ADDENDUM NO. 02

Project: Arthur Area Community Centre Renovation

ADDENDUM

SECOND FLOOR DEMOLITION PLAN – PLUMBING AND DRAINAGE
SCALE: 3/16"=1'-0"

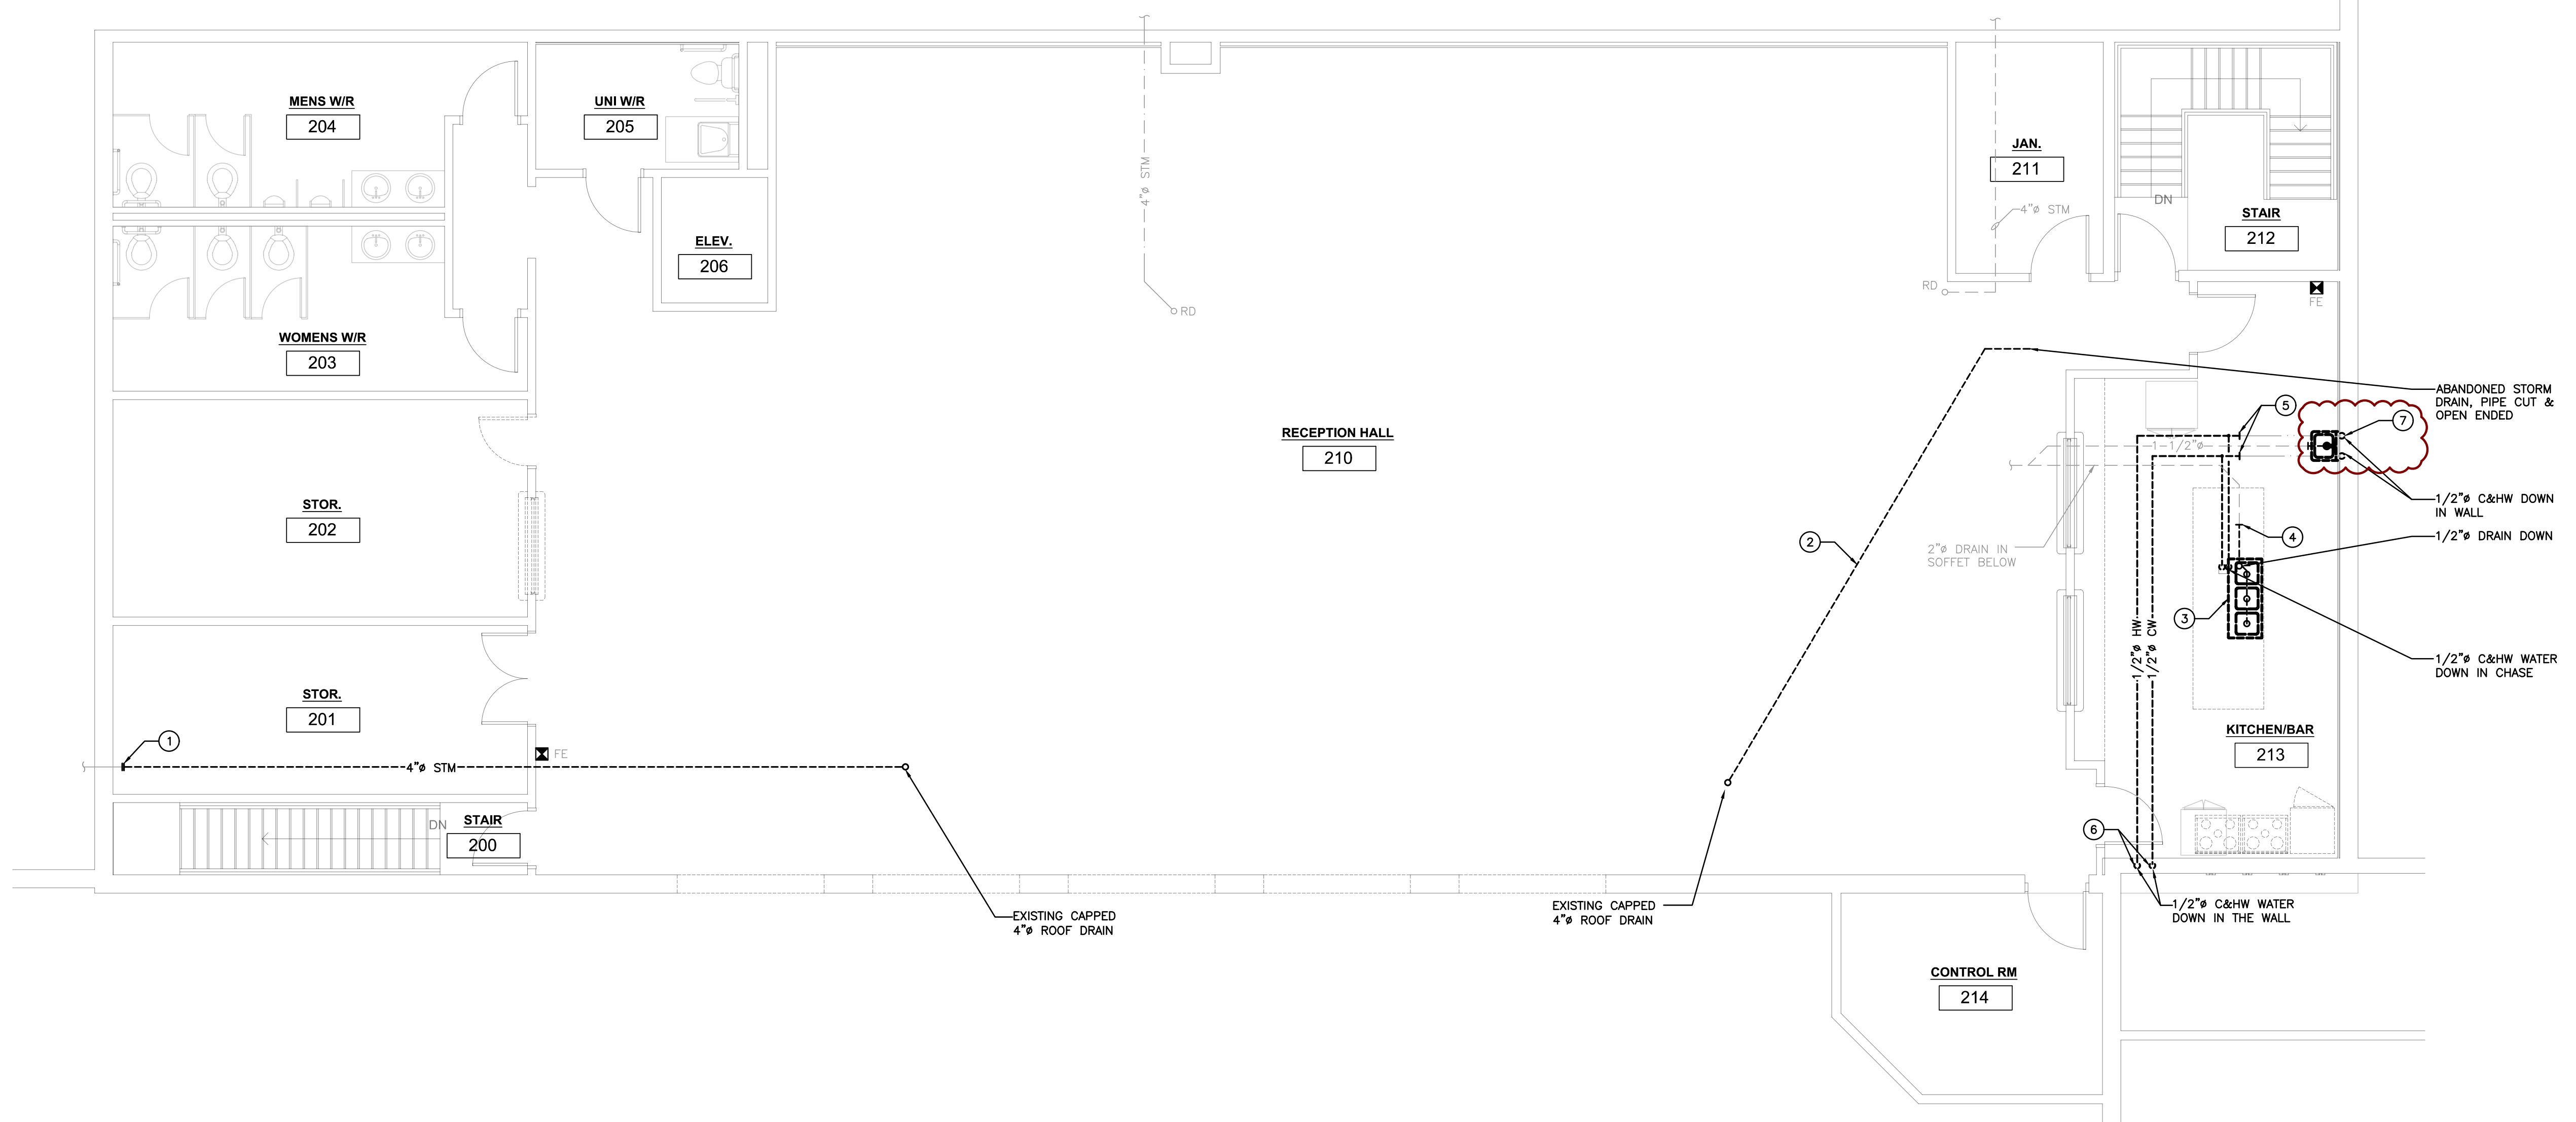
- 3.0 Reference Attached Reissued Drawings M2.1 and M3.1
.1 Existing handwash sink to be removed and replaced.

1. CUT AND CAP PORTION OF ACCESSIBLE ABANDONED STORM DRAINAGE PIPE. REMOVE BEYOND COMPLETE.
2. REMOVE EXISTING ABANDONED STORM PIPING.
3. EXISTING SINK TO BE REMOVED COMPLETE. CUT EXISTING WATER CONNECTION AND PREPARE FOR NEW SINK INSTALLATION.
4. CUT EXISTING SANITARY LINE AND REMOVE VERTICAL PIPING. PREPARE FOR NEW CONNECTION. CO-ORDINATE WITH ARCHITECTURAL TRADE TO SAWCUT FLOOR AS REQUIRED FOR INSTALLATION OF NEW DRAINS BELOW SLAB.
5. CUT EXISTING 1/2" C&HW AND PREPARE FOR NEW CONNECTION.
6. REMOVE EXISTING 1/2" C&HW BACK LOCATION WHERE PIPE IS LARGER. LEAVE HANGERS IN PLACE FOR INSTALLATION OF NEW 1" PIPE.
7. EXISTING HANDWASH SINK TO BE REMOVED. PREPARE EXISTING 1/2" H&CW AND 1-1/2" SANITARY PIPING FOR NEW SINK CONNECTION.

SECOND FLOOR RENOVATION PLAN – HVAC
SCALE: 3/16"=1'-0"

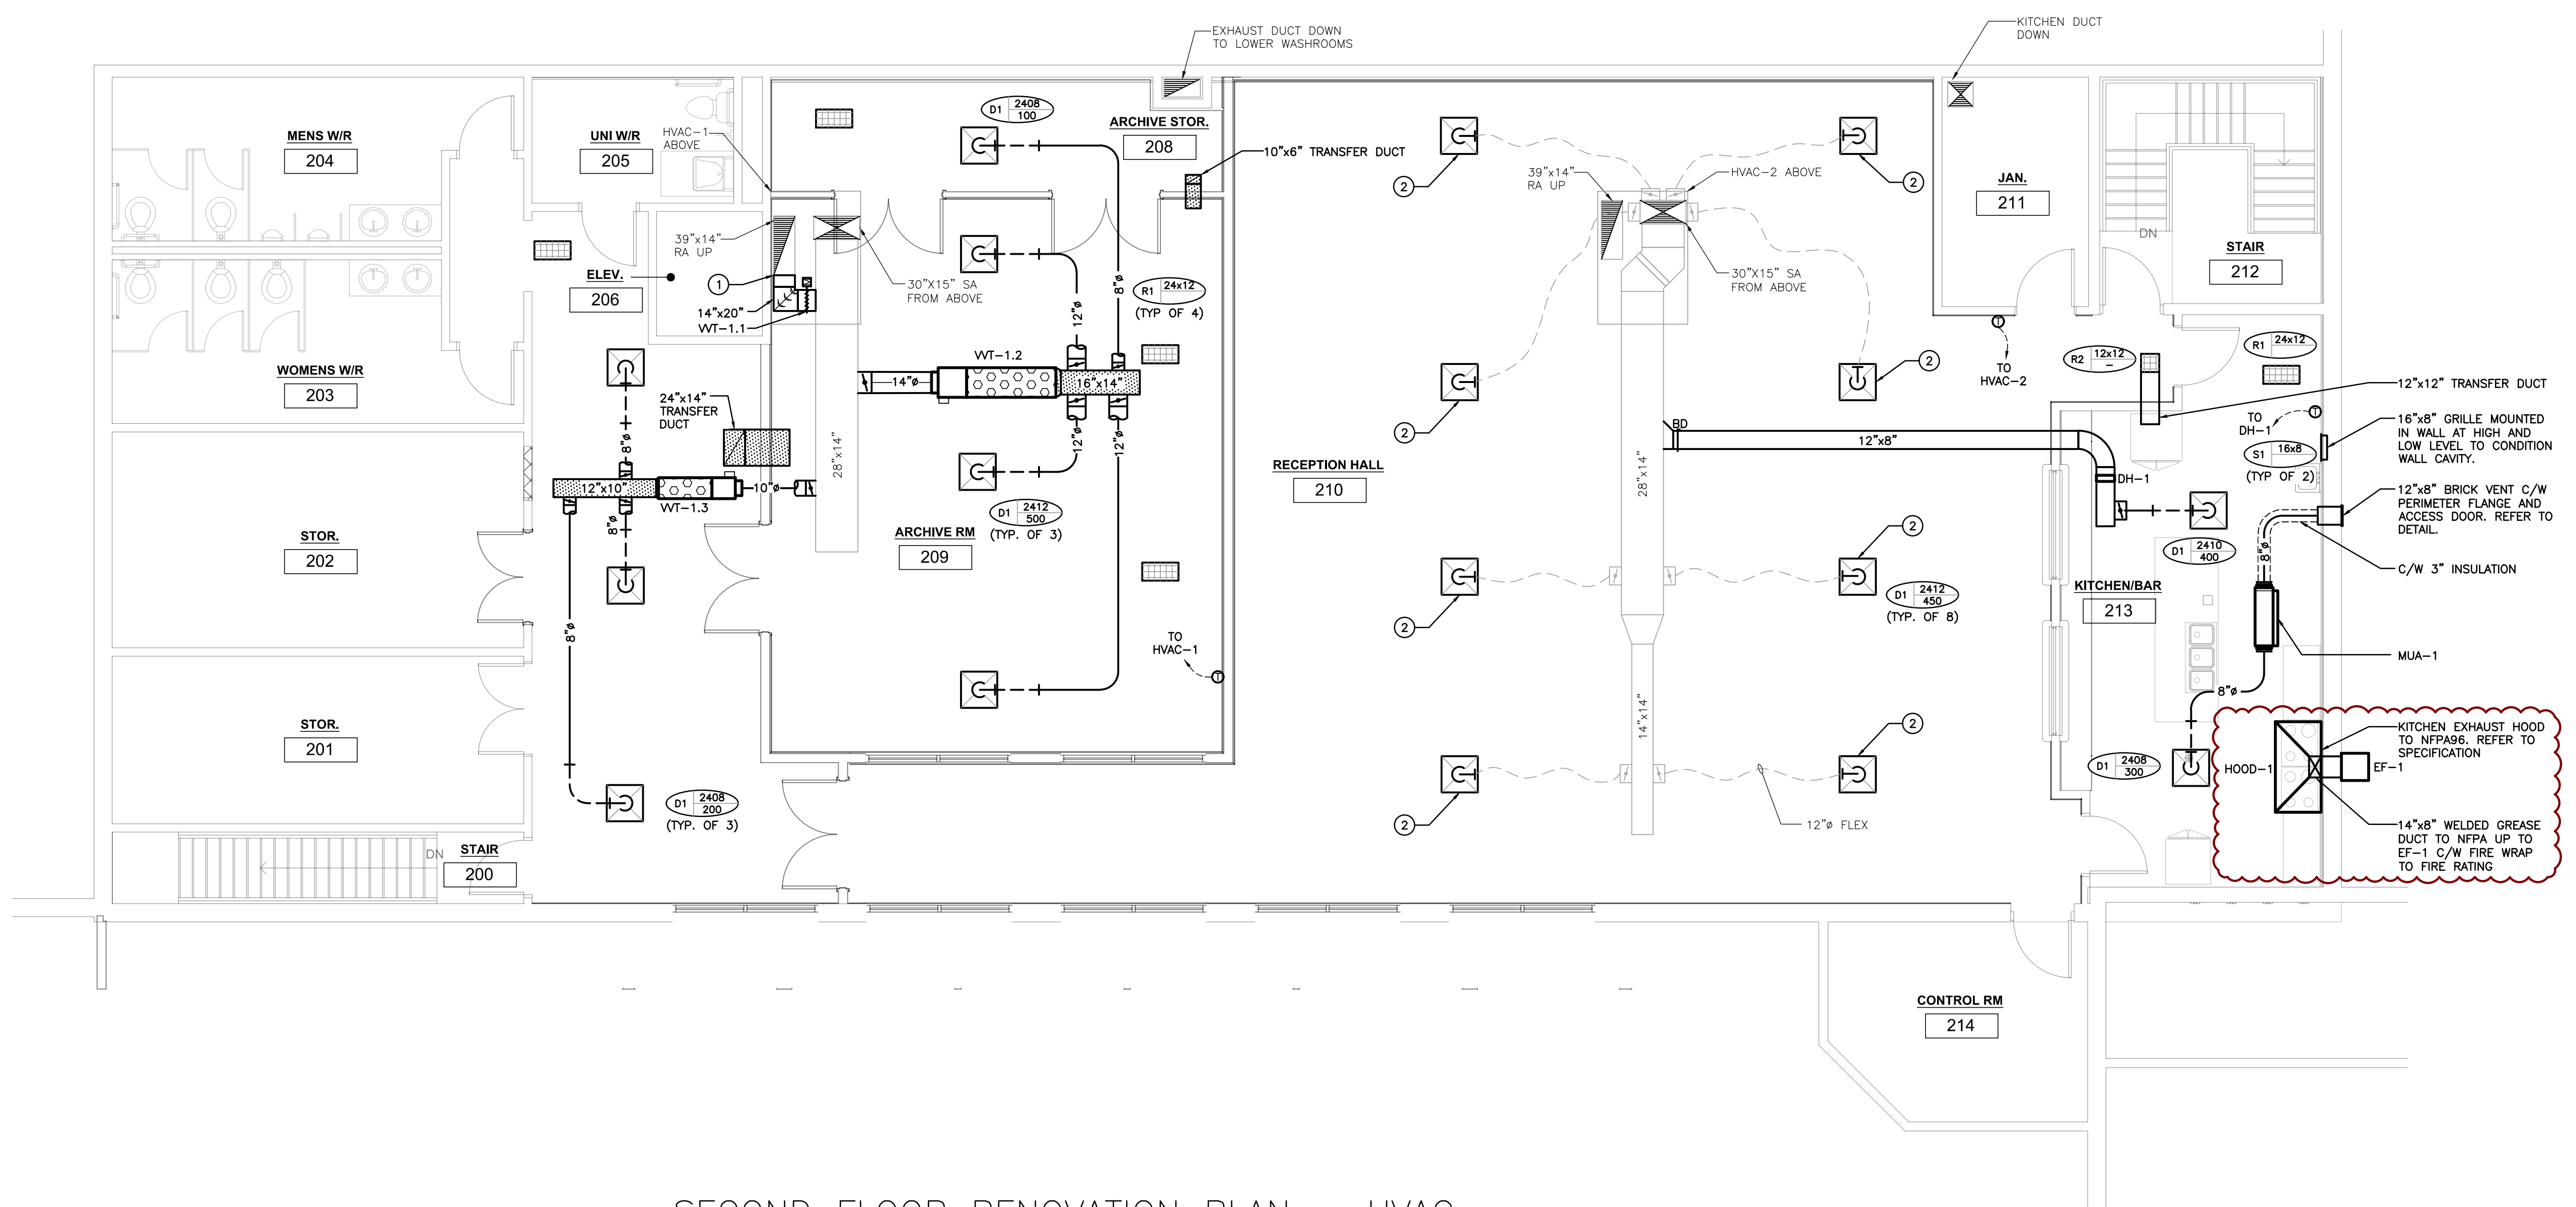
- 4.0 Reference Attached Reissued Drawings M3.2 and M3.3
.1 EF-1 changed to a sidewall fan and removed from the roof.
